10.10. Willoughby Road Consultation Outcome Report

The purpose of this report is to advise Council of the results of the Community Consultation that has been undertaken for the design options for the Willoughby Road Streetscape upgrade and to seek endorsement on the preferred final design option.

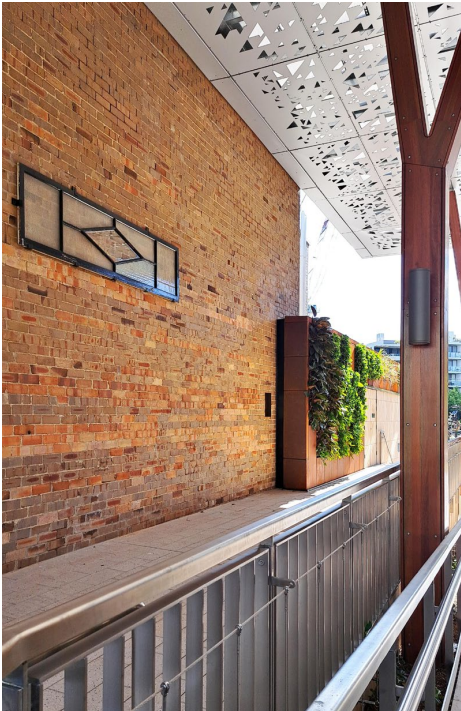
No.	Name and Address	Preferred Option	Comments	Code
7	Site walkthrough on 2 November 2022	Option 2	<p><u>Overview of project</u></p> <ul style="list-style-type: none"> • Improve road safety at pedestrian crossings by improving site lines (by replacing high planter boxes with lower planting) • Renovate the streetscape and fix uneven paving (trip hazards) • Improve lighting to activate the night time economy (restaurants, etc) and safe public domain (no dark spots) <p><u>Feedback</u></p> <ul style="list-style-type: none"> • Neither option is reflecting the village character (looks like the Gold coast, not Crows Nest) • We would like Willoughby Road to be treated as the heart of a village not a CBD • The Willoughby Road upgrade ought to integrate with the new walk-through to Hume Street • Disliked the proposed concrete - preferred material in Hume street walkway (sandstone, timber) <i>Thinking: concrete wall along road, different material like thin GRC panel or other on footpath side for aesthetics from footpath view</i> • Wants the look to be green ie planting • Would like the existing plants to be re-used • Pavers need to be slip resistant • 2 participants liked option 2 (modular) • We would like the design to be elegant • More wood, organic materials • Match heritage of the village • Reflect rectilinear shape, which may be a more efficient use of space • Solution for trip hazards on dining terraces(photo below)

No.	Name and Address	Preferred Option	Comments	Code
			<ul style="list-style-type: none"> <li data-bbox="815 201 1877 260">• Reference to the history of the villages such as Hume street eg salvaged window from Penfolds building on Hume Street park walls (photo below)  <ul style="list-style-type: none"> <li data-bbox="815 979 1682 1007">• Likes planting near Woolworths, but not the skinny pear trees (photo below)  <ul style="list-style-type: none"> <li data-bbox="815 1366 1525 1393">• Existing bus stops to be retained on Willoughby Road - Agreed
